From: Dominick Thomas <djt@cohen-thomas.com>
Sent: Wednesday, November 8, 2023 4:40 PM
To: Mathews, Lisa A <Lisa.A.Mathews@ct.gov>
Cc: Schaefer, Jon <JSchaefer@rc.com>; CSC-DL Siting Council <Siting.Council@ct.gov>; ali.weaver@siliconranch.com; Kenneth C. Baldwin, Esq. <kbaldwin@rc.com>; Rachel Mayo <rmayo@rc.com>; Ron Viola <vmron@yahoo.com>
Subject: Re: Petition No. 1442 Council Partial D&M Plan III Interrogatories

LITCHFIELD
SOLAR

PERMANENT POND DETAILS
AND CROSS SECTIONS

WET SWALE 11
H: 1" = 20'; V: 1" = 4'

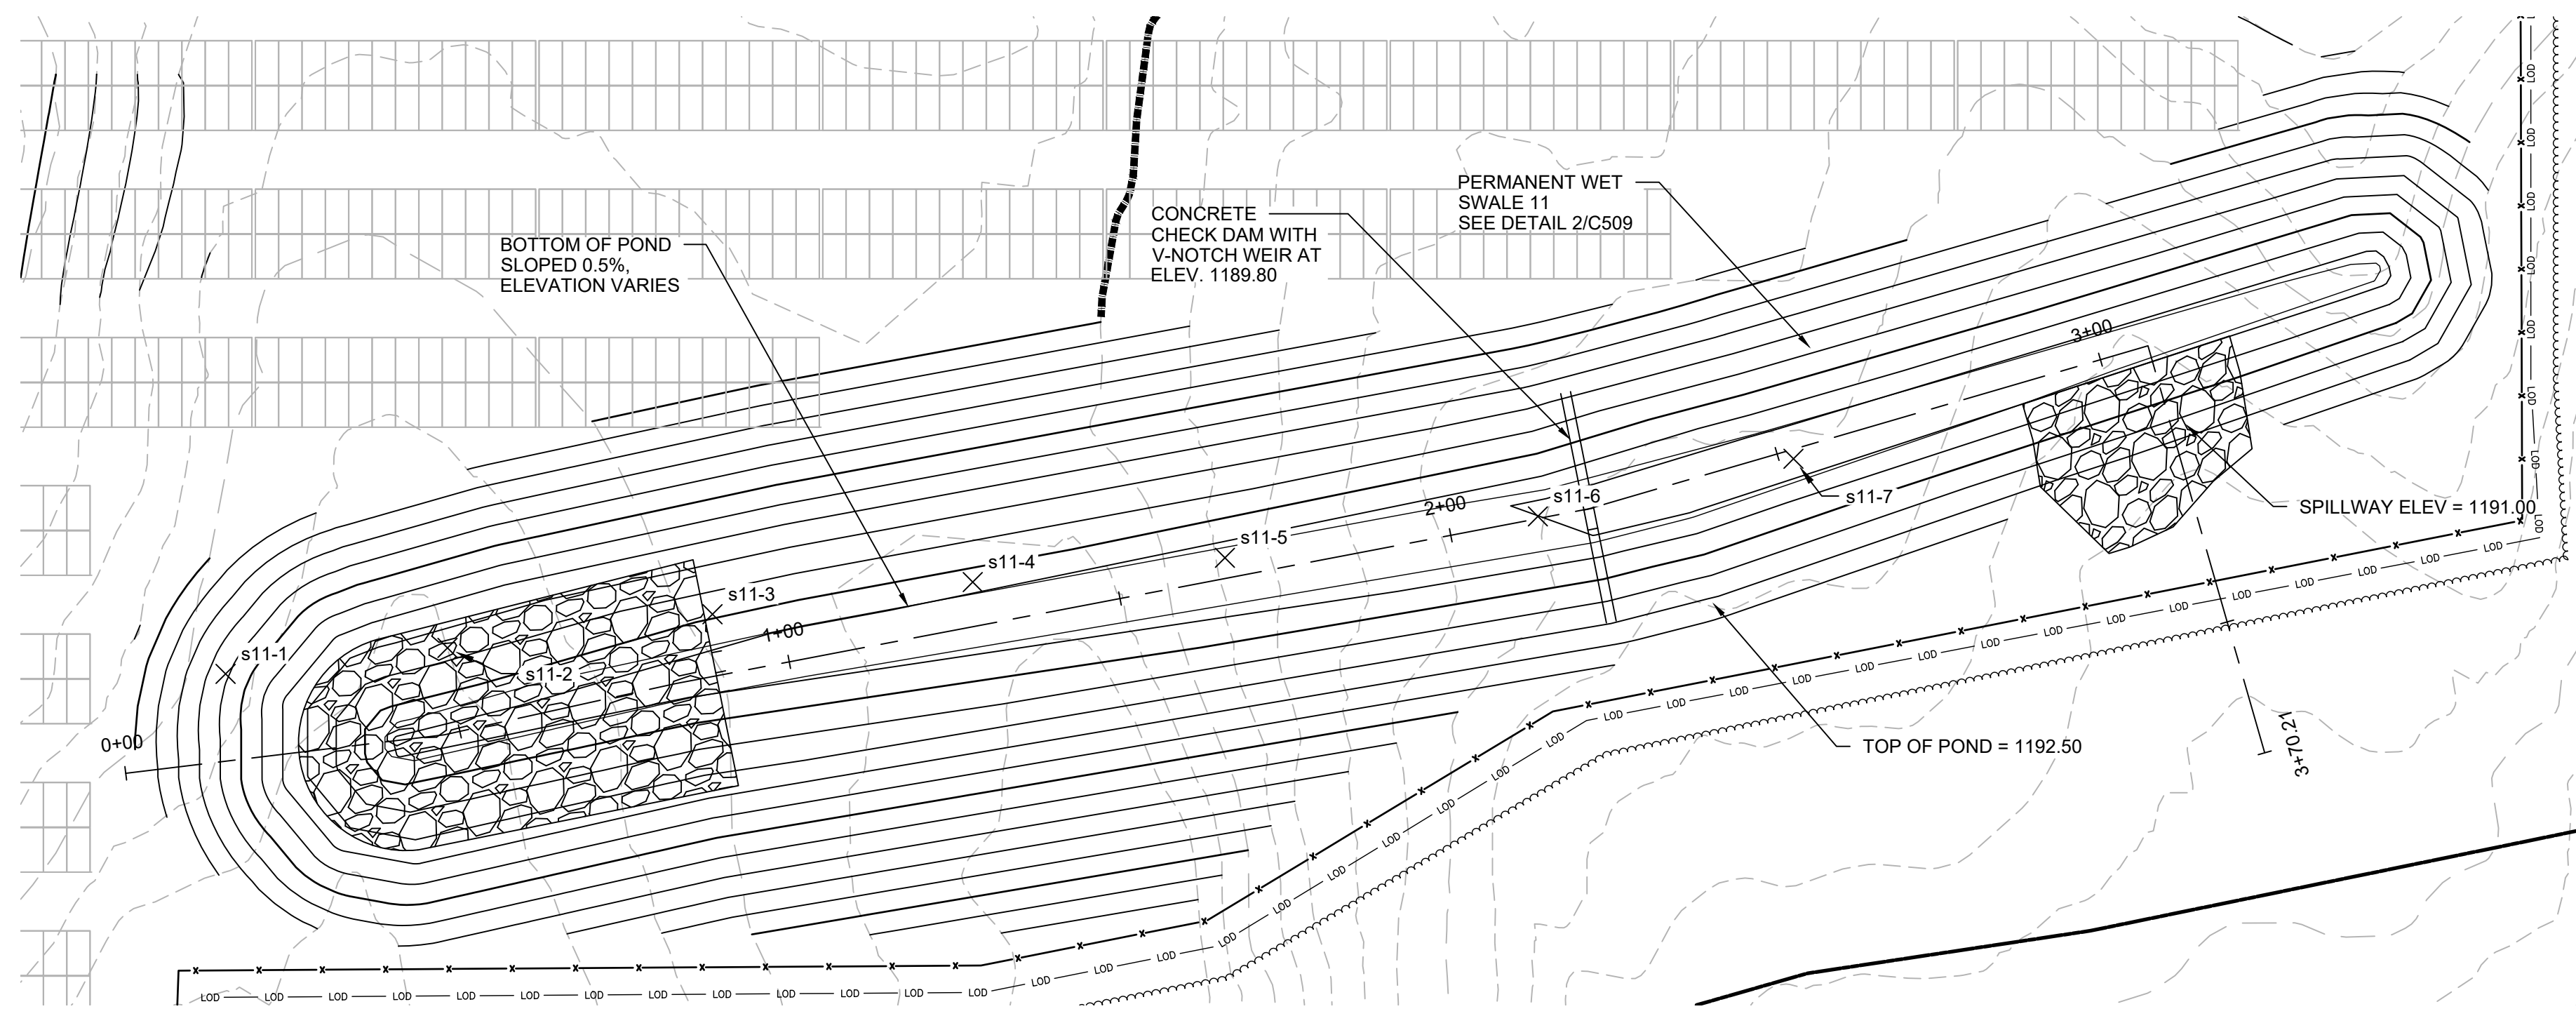
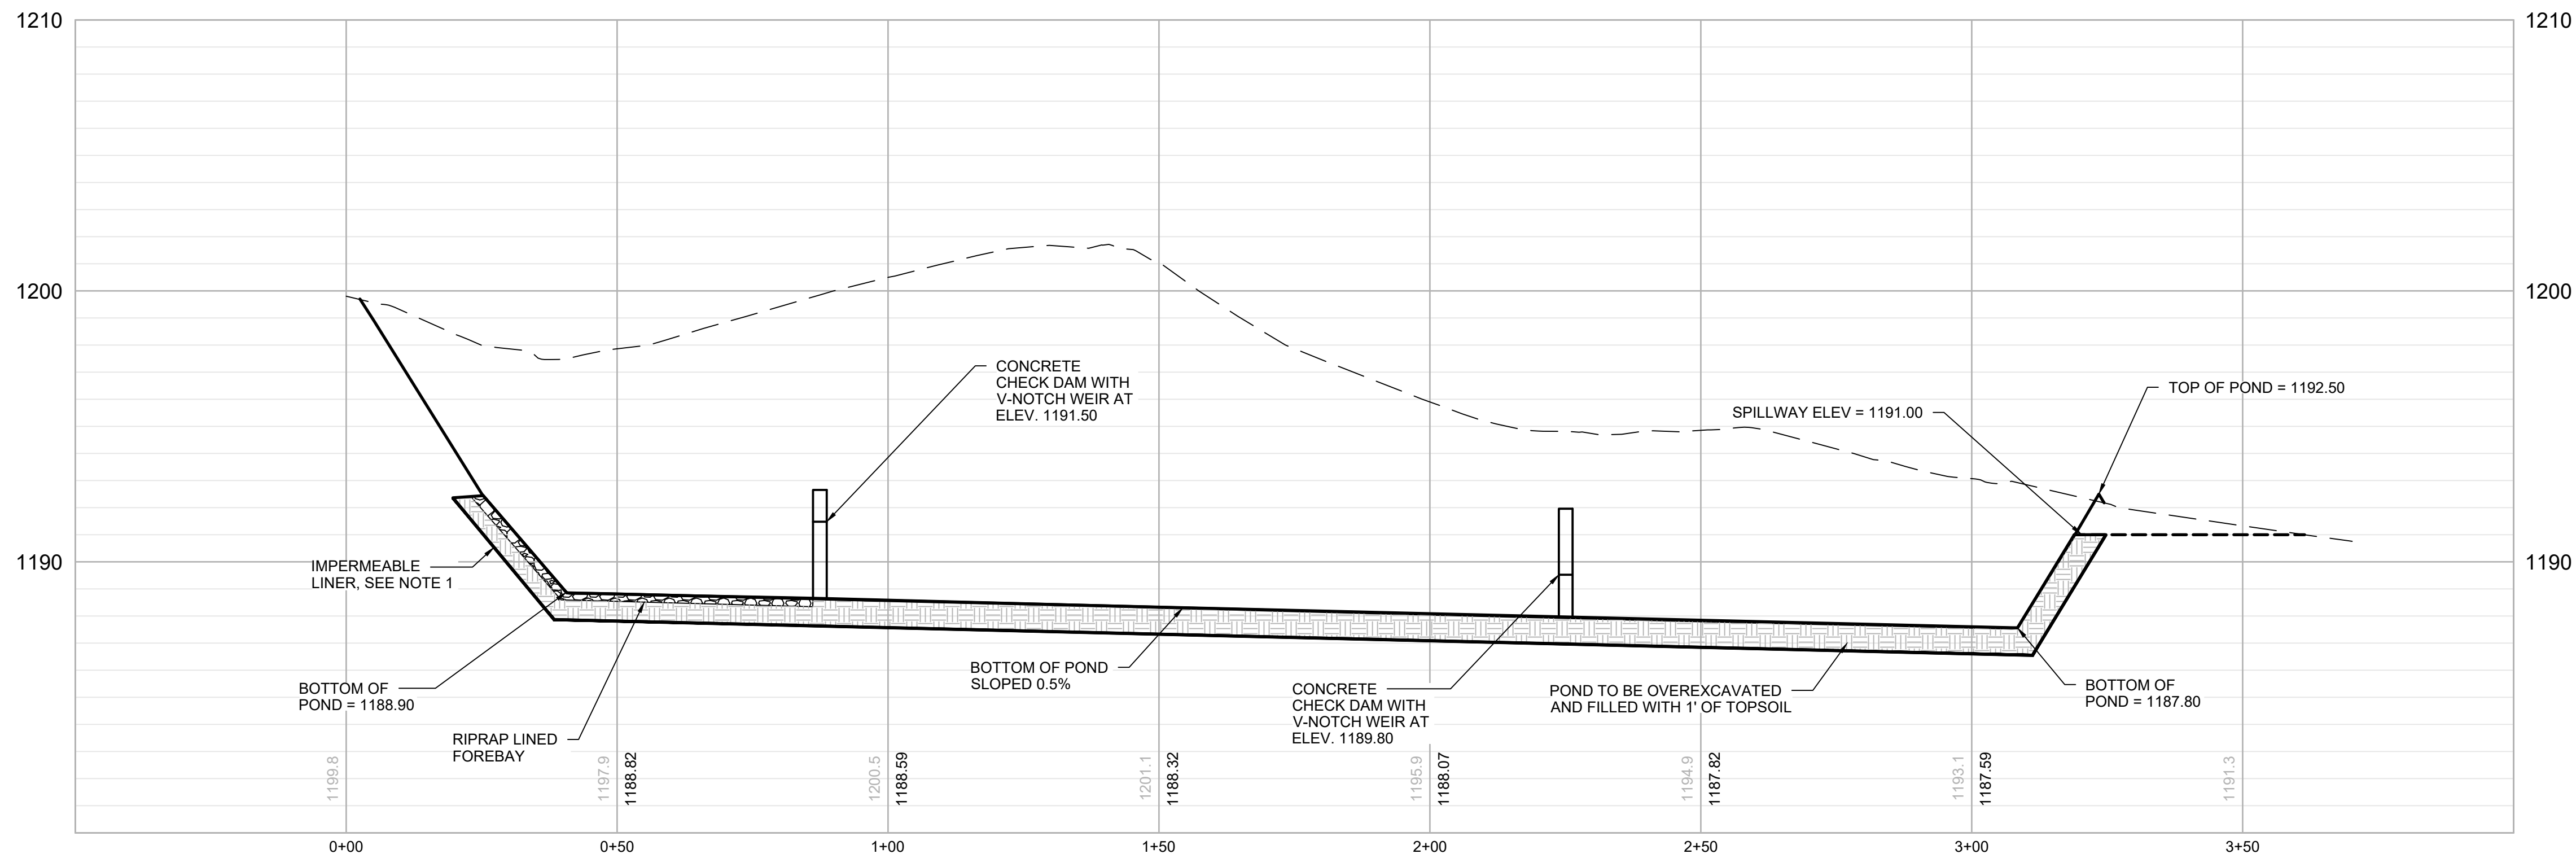
I represent Ronald Viola, an abutter to the project and a party to the application. My client has reviewed the revised plans and has serious concerns over the redesign of wet swale 11 which my client has been informed was required by DEEP as part of the General Permit. I note that your recent interrogatories address some DEEP issues. From the original design which had the outlet of a proposed detention basin facing the severe slope down to my client's property (which area is subject to a conservation easement), the basin was changed to a wet swale with ground water recharge and an outlet toward the west and a receiving wetlands. The recent plans have the wet swale enlarged, pitched away from the wetlands, with an impermeable liner and an emergency discharge onto the slope that leads down to my clients property. (See attached) I was able to explain this to a couple of engineers who could not understand the design. Why is there an impermeable cover for the bottom and an emergency spillway located to dump water down a hill toward my client's house? That area of my client's property is subject to a conservation easement. They cannot understand at all the purpose of the liner which turns the swale into a pool that will gather water, fill up and discharge through the spillway. Also, does the design de-water the wetlands to the west or impact the existing watersheds since it has no groundwater recharge and seems to serve as some sort of a retention pond with overflow discharge. My client believes this needs to be looked at and the reasons for the change explained by either DEEP or the applicant.

I would hope the CSC will look into this matter before letting the construction begin on the revised plans.
